# UNITED STATES PATENT AND TRADEMARK OFFICE

10/823,634

# Office Action Summary

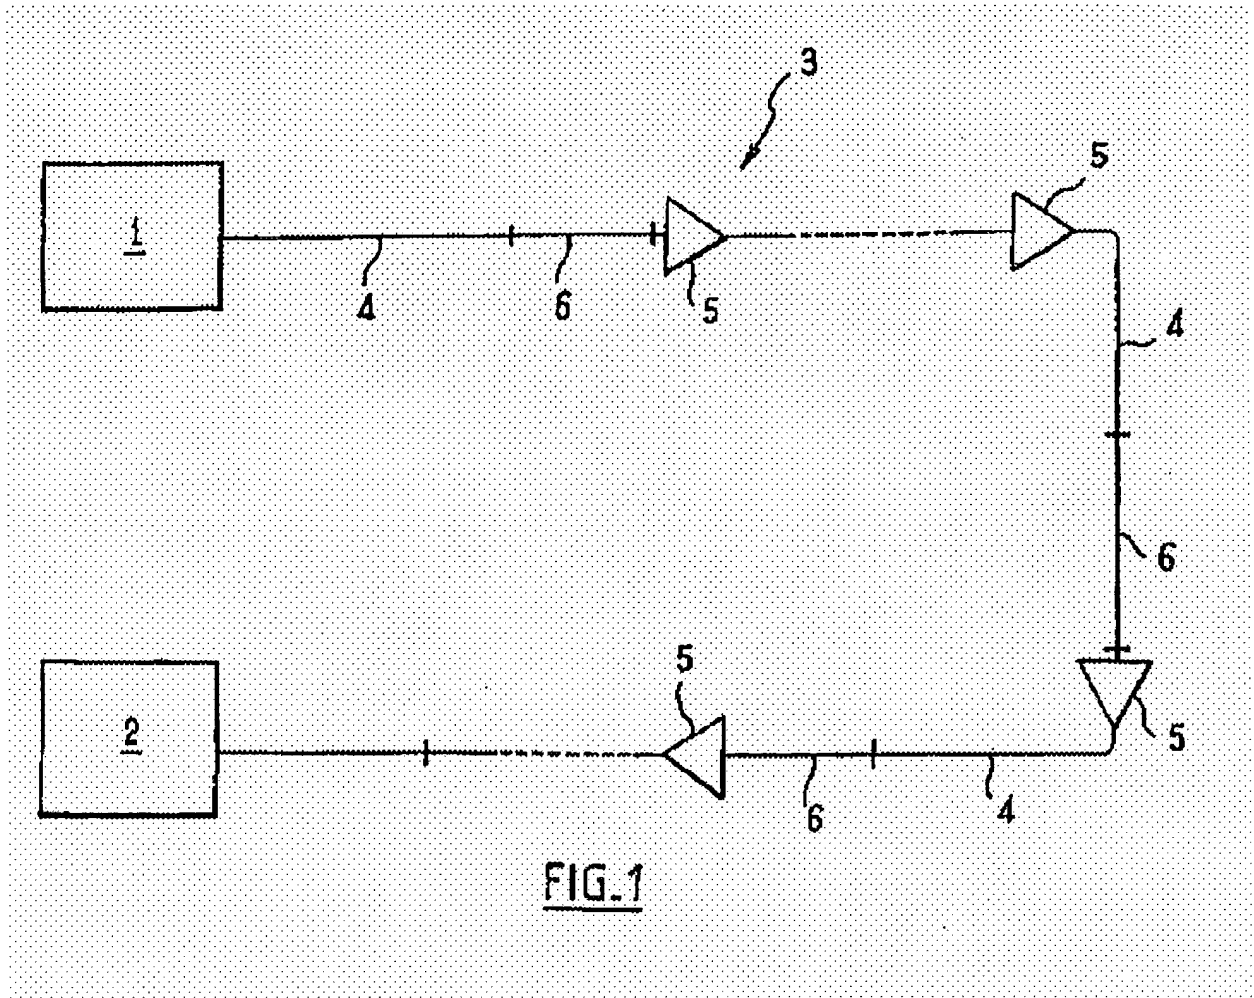
6. Claims 92 and 96-98 are rejected under 35 U.S.C. 102(e) as being anticipated by Georges (U.S. 6,941,037).

With respect to claim 92, Georges (figure 1) discloses an apparatus comprising a first compensator (6) compensating wavelength dispersion, the first compensator (6) having a constant wavelength dispersion characteristic over a plurality of wavelengths; and a second compensator (6) compensating wavelength dispersion after wavelength dispersion is compensated by the first compensator (6), wherein the first and second compensators (6) together compensate for wavelength dispersion dependent on a respective wavelength of a transmission line (3) (see column 2, lines 29-41; column 3, lines 34-41 and lines 50-55).

With respect to claim 98, Georges (figure 1) discloses an apparatus comprising first means (6) for compensating wavelength dispersion, the first means (6) having a constant wavelength dispersion characteristic over a plurality of wavelengths; and second means (6) for compensating wavelength dispersion after wavelength dispersion is compensated by the first means (6), wherein the first and second means together compensate for wavelength dispersion dependent on a respective wavelength of a transmission line (3) (see column 2, lines 29-41; column 3, lines 34-41 and lines 50-55).
